Subject: **FCC Class II Permission Change Request for FCC ID: OU5B1X501**

This is to request a Class II Permission Change Request for FCC ID: OU5B1X501, originally granted on 2017/02/24.

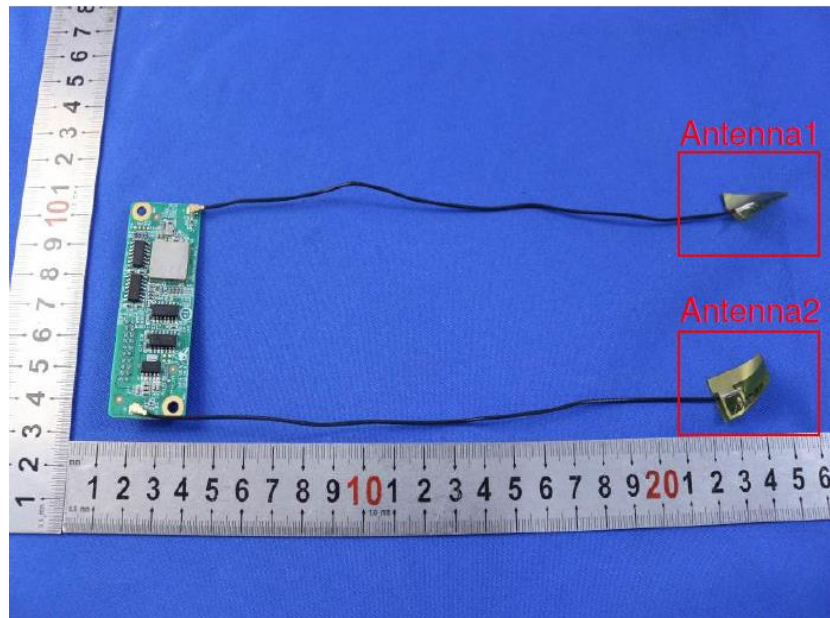
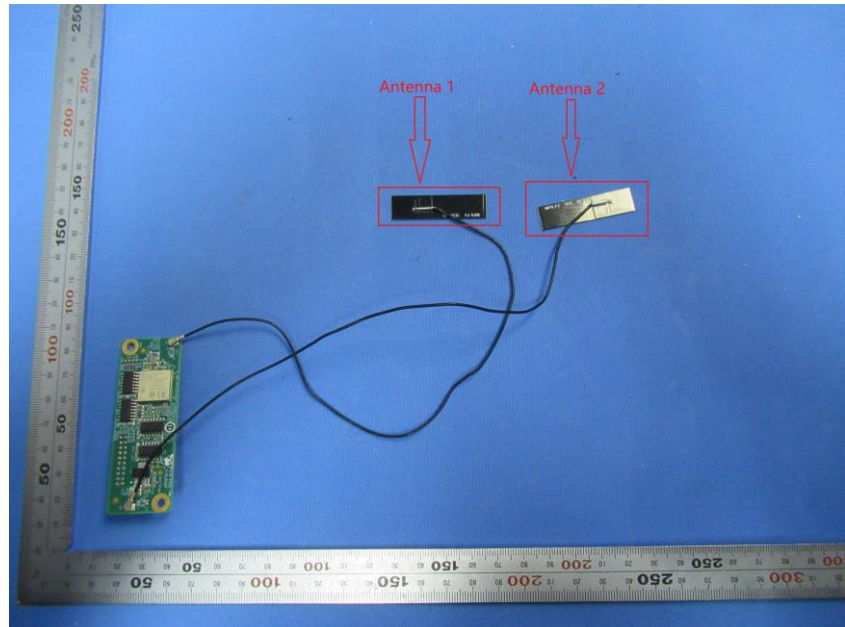
Has only updated antenna as below:

Original:

antenna gain 2.4GWiFi Antenna 1/Antenna 2: 2.2dBi

5GWiFi Antenna 1:4.5dBi

Antenna type PIFA Antenna

New:

antenna gain 2.4GWiFi Antenna1/Antenna2:3.2dBi

5GWiFi Antenna 1:4.5dBi

Antenna type FPC Antenna
